R.M.63 M.M./400 CAP
 MOLD-RITE PLASTICS INC.
 PLATTSBURGH, NEW YORK

DRAWING REVISION PAGE

SUBJECT: RM-63MM-400 CAP

DOC: C-4014

TOLERANCE: +/- .010
 SCALE: FULL DATE: 3-17-97
 DRAWN BY: P.D.T.
 DRAWING NO. C-4014

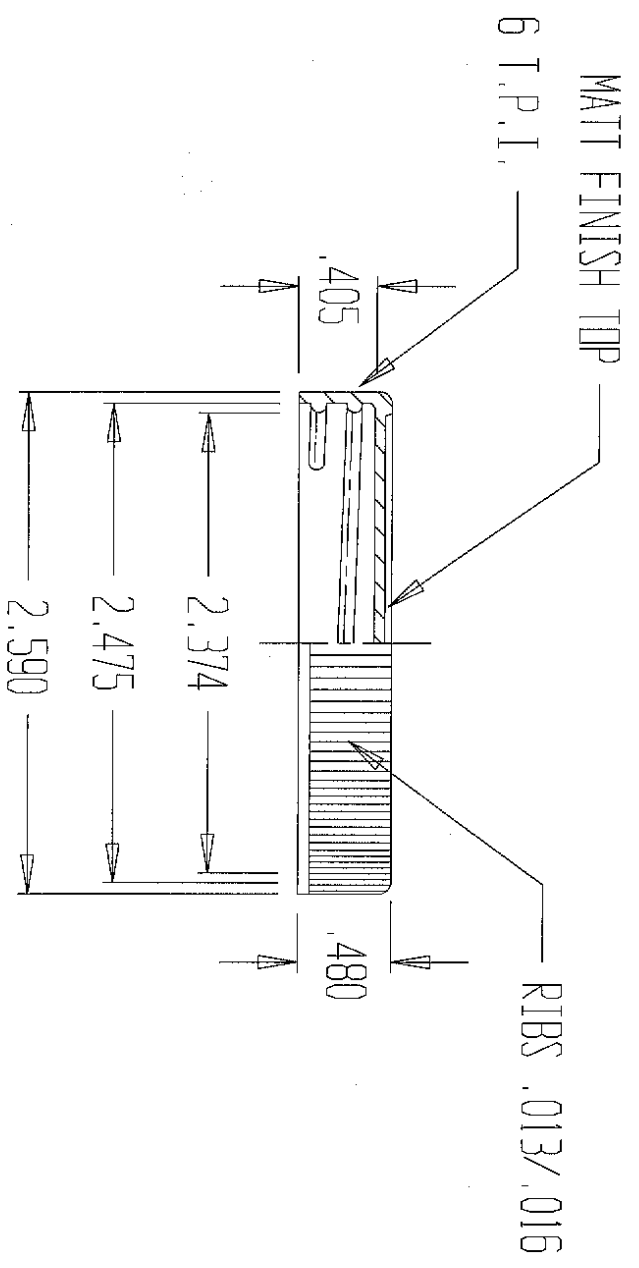
REV LEVEL	REV DATE	DESCRIPTION OF CHANGE
1	Dec. 05, 2003	Drawing requires update. Changed E=2.374 to match actual product. Added weight tolerance of +/-1.5 grams. No Tooling Change.

"I"	"E"	"H"	"A"	"B"
2.475	2.374	.405	2.590	.480

WEIGHT: 7.0 GRAMS +/- 1.5 grams
